GREAT BRIDGEWATER STREET

Visual Mock-Up (VMU) - Report

Rev. D - 16.02.23

JOINT ARRANGEMENTS

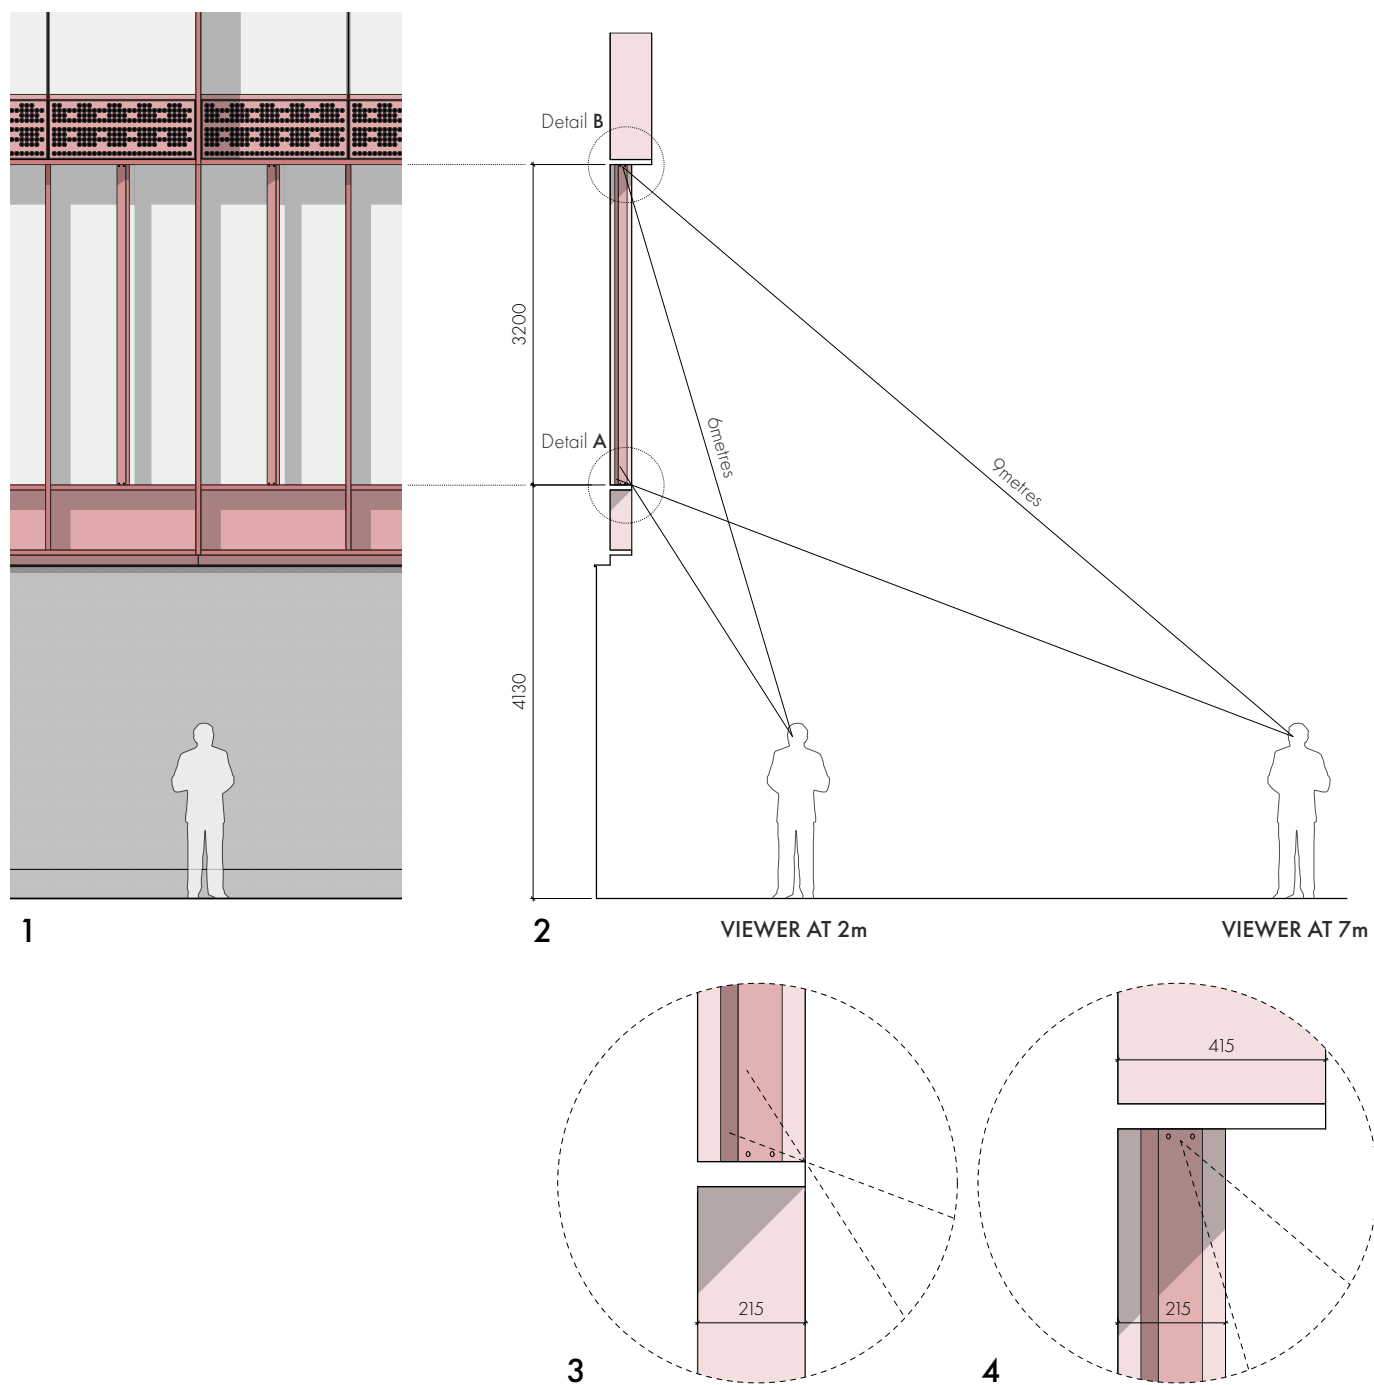
- B Joint Arrangement**
Included below is a full demonstration of the practical and maintenance requirements for the various joint sizes across the project and which are included within the VMU.
- C Fixing Locations & Visibility**
Included below is a series of diagrams showing the visibility of these fixings when positioned in the correct vertical position on the facade.
- D VMU Remedial Works**
Included below is a series of annotated images of the VMU indicating the necessary remedial works required to demonstrate the quality assurance controls that will be adhered to during the facade installation. These works relate to the following:-

The fin joint sizes are a result of two factors determining the need to maintain this spacing. Firstly a detailed structural analysis has been undertaken to establish the likely movement of the new and existing structural elements. This determined the parameters of the new facade system and the movement it would be required to accommodate and the tolerance of the new and existing elements.

The 15mm joint gap is a result of this detailed work but an additional factor has been ensuring the ease of replacement should fins become damaged - ensuring replacement is practical and without unnecessary dismantling of adjacent elements will ensure the longevity of the building. Any additional gaskets would be impractical to install, would easily be damaged due to the building movement and would likely cause a significant long term maintenance issue as these moved, fell out of place or distorted over time.

REF - 70 GBS-VMU-ZZ13

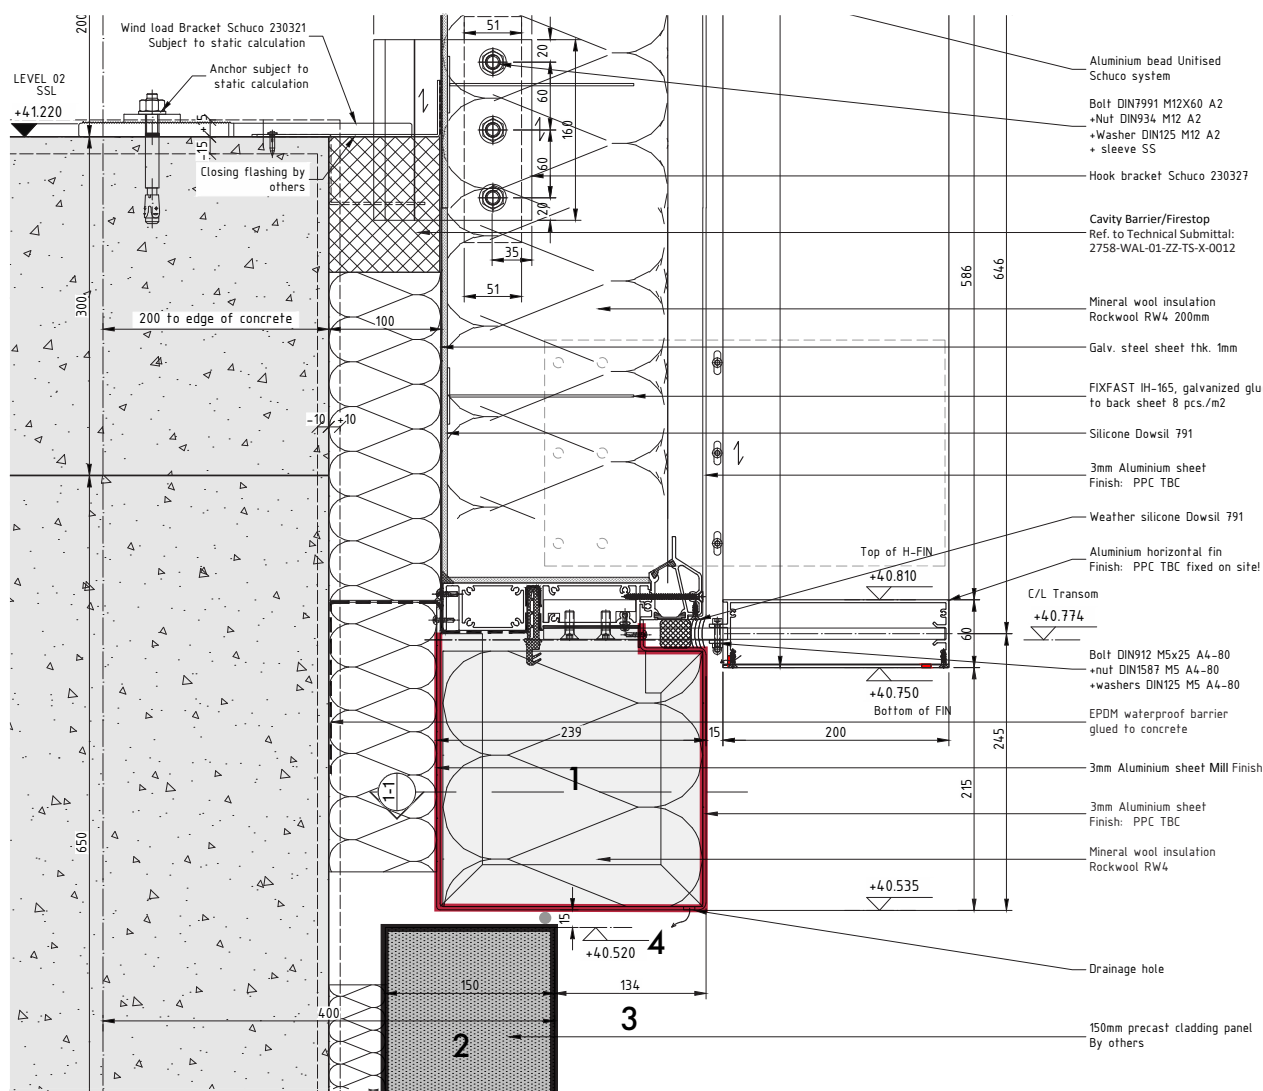
Junction of unitised to precast concrete - the detail as installed is not correct and this will be removed and addressed; included below is the proposed sectional detail of the corrected installation.

Stack-joint gasket - as noted the gasket at 'floor' level on the VMU (left hand panels) is poorly installed and this will be re-set to rectify this issue.

Fin alignment - minor deflection between horizontal fins will be adjusted to ensure full alignment.

- 1 - Junction of unitised to precast concrete
Review and amend detail - see drawing on following page
- 2 - Stack-joint gasket
Quality assurance issue - notify contractor and correct
- 3 - Joint Alignment
Quality assurance issue - notify contractor and correct
